Rezoning Transportation Analysis

Petition Number: 2022-118

Date	Description
12-29-22	First Review (IW)

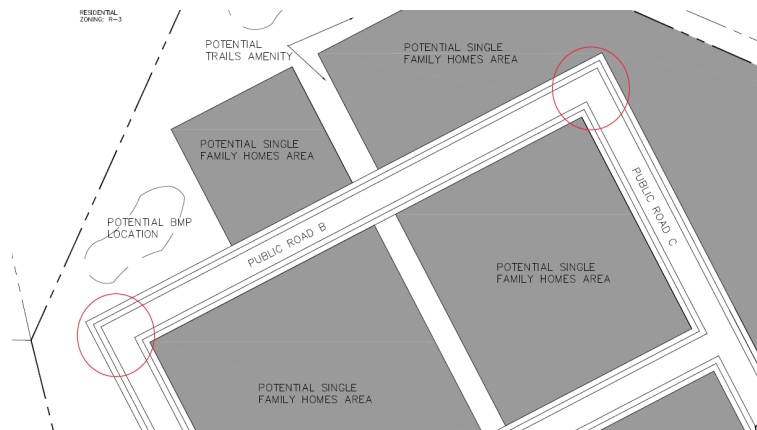
7. Revise site plan and conditional note(s) to commit to installing a left turn lane for access off of Harrisburg Road per coordination with NCDOT.
8. Revise site plan and conditional note(s) to commit to extending stem length of Cedarbrook Drive Extension to 100 feet, no parking within that stem. Per coordination with NCDOT.
9. Revise site plan and conditional note(s) to commit to acquiring right of way prior to permit approval. Per coordination with NCDOT.
10. CDOT Request: If possible, revise site plan and conditional note(s) to commit to improving Cedarbrook Drive alignment per coordination with NCDOT.
